Fort Field Diversion Dam Reconstruction

Final Environmental Assessment

March 2008

Comment letters and emails were received on the Draft EA. These were received from:

Figure 3 Fort Field Conceptual Design

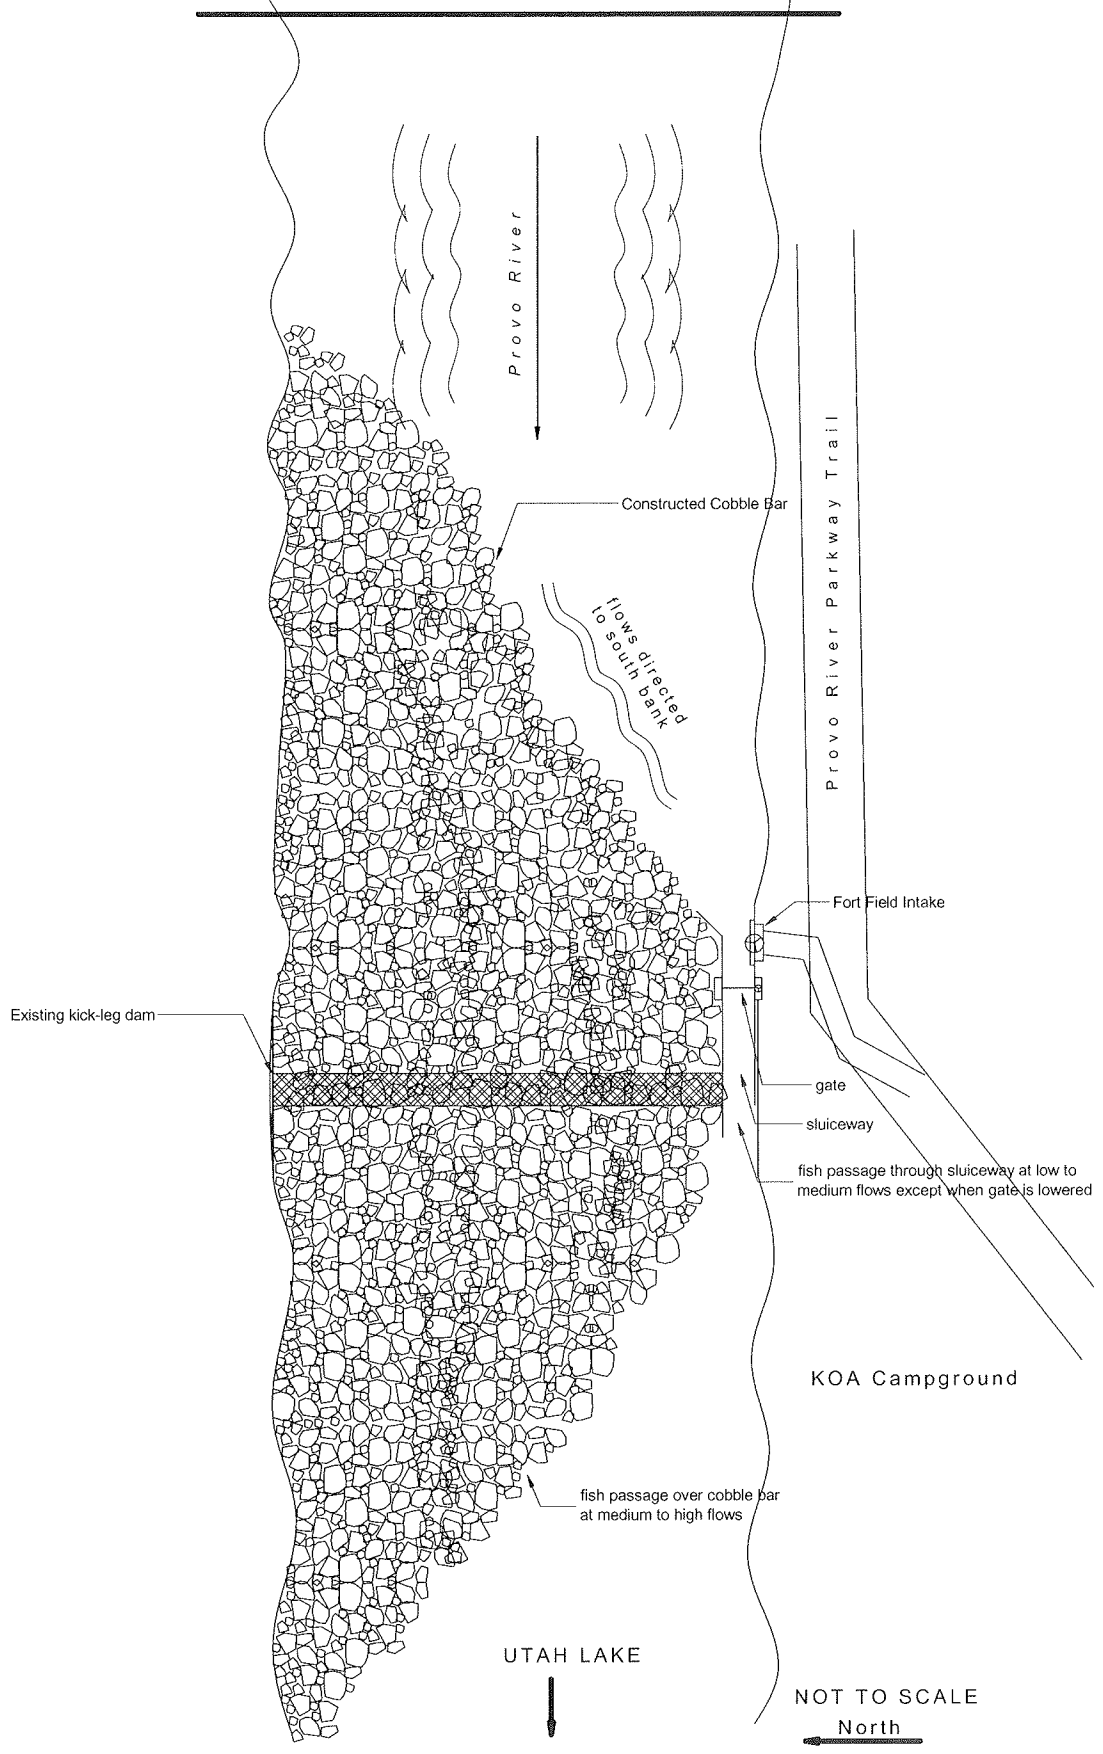
Comment 1: Verification needs to be made that the water surface profile of the river during high flows is not elevated as a result of the proposed reconstruction.

Comment 2: Given the shallow ground water problems experienced in nearby residential areas during moderate to high flows in the river, we would recommend the provision of a clay layer under the cobble bar in disturbed areas of the river bed to minimize potential exacerbation of those ground water problems.

Comment 3: Is the structural design of the kick-leg dam such that it could withstand high flows? Higher flow rates typically cause an increased structural load on the removable dam components. Are the water users required to maintain this structure in order to divert during low flows?

Comment 4: It appears that the cobbles would actually increase the maintenance associated with the kick leg dam structure.

Comment 5: Replacing the kick leg dam with a permanent concrete wall dam would prevent the need for maintenance of the existing kick leg dam preventing seepage losses through the dam and enabling a better measurement of flows.

Comment 6: There would be a resulting increased sediment load into the diversion if sediment doesn't pass under the proposed sluice gate, particularly during high flows. It is important that the diversion inlet be somewhat higher than the bottom of the channel so more sediment will pass downstream.

Comment 7: The higher the elevation of the diversion dam above the riverbed the more potential for channel degradation downstream. In this situation it appears that the proposed cobble material particularly on the downstream side of the dam will need to be attached to the floor of the structure and/or the bottom of the streambed in order to remain in place during high flows. Alternatively the cobbles could be replaced after each high flow event in order to allow fish migration over the dam.

Comment 8: It appears that the proposed structure could increase the migration of the river channel towards the left bank. The proposal should include channel armoring such as gabions along this left bank where there is potential for bank erosion or scouring.

Comment 10: Removable weirs serving as a fish ladder in the sluiceway would likely enable fish movement with significantly less flow when the sluice gate is open.

Comment 15. On page 5 I had a couple of questions about the design. Will the fish get directed into the intake as they swim by? Would sediment back up behind the cobble bar?

Response: Modeling of the water surface elevations of the conceptual design in the EA, with data from Bowen and Collins Engineering, indicates that the water surface elevation immediately upstream of the Fort Fields Diversion structure will increase approximately 2.5 ft over existing levels at the 2,300 cfs high flow, as identified by the Provo City Public Works Department. This increase is contained within existing banks at that location and diminishes to nearly zero at a distance of approximately 1,000 ft upstream (at a point located between the Union Pacific Railroad and Highway I-15 bridges).

Response: It is anticipated that the construction of the bar will not worsen the groundwater problems. However, the addition of a clay layer to the diversion structure design will be considered during the final design phase.

Response: The kick-leg dam will be incorporated into the cobble bar under the proposed action. Once the project is complete there will be no removable dam components. The sluice gate channel will be operated in an open position during periods of high flow. The water users would maintain this structure as they do with the existing structure. See also the response to Comment 7.

Response: See comment 3 response.

Response: See comment 3 response. A permanent concrete wall dam would not allow fish passage at low flows and the purpose of providing fish passage would not be met.

Response: The sluice gate would be open during high flows to pass sediment load and prevent silt from accumulating near the diversion intake pipe. The purpose and design of the sluiceway is to pass sediment bed load in the river. During late summer when the river is low and there is less sediment in the river, the sluice gate would be closed and all water would either enter the diversion pipe or pass over the rock sill. The invert of the sluiceway would be lower than the invert of the diversion pipe.

Response: The rock used in the sill will be essentially immobile even at high flows. Some smaller material will move into and out of the area during high flows. Maintenance of the rock sill will not be needed during most years.

Response: Increased protection along the left bank is included in the existing conceptual design, but only below the structure. The need for additional protection upstream of the structure has been discussed in the field, and will be included in the final design if it is deemed necessary.

Response: Various fishway designs were evaluated during planning for this project. However, due to the lack of space in the project area, and the requirement for low gradients and velocities, these options were not considered to meet the purpose and need of providing fish passage for species such as June sucker.

Response: It is not anticipated that spawning June sucker moving upstream near the Fort Fields diversion structure will be directed into the diversion intake. Entrainment of downstream drifting larval June sucker may occur, but these small losses are thought to be offset by the increased access to spawning habitat. In response to sediment backing up behind the cobble bar, see the response to Comment 7.
